# UNITED STATES PATENT AND TRADEMARK OFFICE

APPLICATION NO.	FILING DATE	FIRST NAMED INVENTOR	ATTORNEY DOCKET NO.	CONFIRMATION NO.
09/800,006	03/06/2001	James C. Rush	STE01 P-1086	5256
277 7590 05/31/2007 PRICE HENEVELD COOPER DEWITT & LITTON, LLP 695 KENMOOR, S.E. P O BOX 2567 GRAND RAPIDS, MI 49501			EXAMINER HORTON, YVONNE MICHELE	
			ART UNIT 3635	PAPER NUMBER
			MAIL DATE 05/31/2007	DELIVERY MODE PAPER

<b>Office Action Summary</b>	Application No.	Applicant(s)	
	09/800,006	RUSH ET AL.	
	Examiner	Art Unit	
	Yvonne M. Horton	3635

FIG. 2A

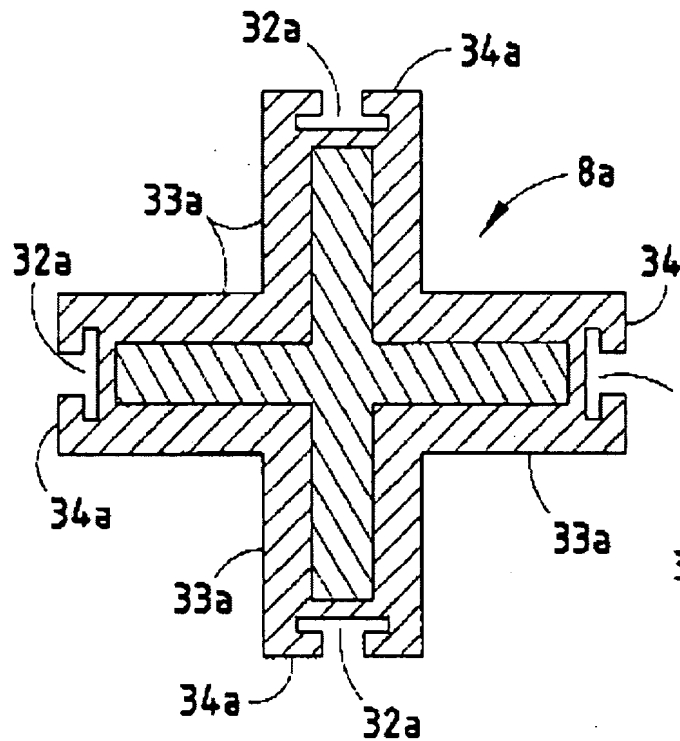
Claims 76,78 and 100-102 are rejected under 35 U.S.C. 102(e) as being anticipated by US Patent #6,481,169 to LUDWIG et al. LUDWIG discloses the use of a post and beam furniture system for partitioning open including a plurality of overhead beams (6), each having opposite ends; a plurality of vertical posts (8), each having a lower portion (35a,d) thereof adapted to be abuttingly supported in a freestanding fashion on a floor surface of the open office space in a laterally spaced apart relationship, and an upper portion thereof operably connected with the opposite ends of said overhead beams (6) to support said beams (8) at a predetermined elevation above average user height; at least one of said posts having an X-shaped plan (see figure 2A,B) configuration defining four mutually perpendicular, outwardly extending flanges (33a) arranged to define

triangular shaped spaces (in the area of 8a), each of which has an end face (34a) with a single T-shaped vertical slot (32a) extending centrally there along; at least one of said posts (6) having a Y-shaped plan configuration (see figure 2C,D) defining three regularly spaced apart, outwardly extending flanges (33d) arranged to define triangular shaped spaces (in the area of 8d), each of which has an end face (34d) with a single T-shaped vertical slot (32d) extending centrally there along; and a plurality of beam-to-post connectors (36) attached to the opposite ends of said beams, and detachably retained in said slots (32a,d); and at least one partition accessory (70) having a mount (72) that is detachably retained in the slots (32a,d). Regarding claim 7, the beams (6) includes opposite end faces having the T-slots (28); wherein, each of the slots (28) are generally similar in shape and size to receive the accessory (70) therein. In further reference to claim 100, the vertical posts (8) of LUDWIG has a "cruciform" shape having a central portion (CP) with four of the flanges (33a). Regarding claim 101, the partition accessory (70) that is "configured" to equip the system for users is capable of being detachably retained at a variety of orientations along the length of the post. In reference to claim 102, the beam (6) has a longitudinal slot (28) similar to the slots (32) formed in the flanges of the posts (8).
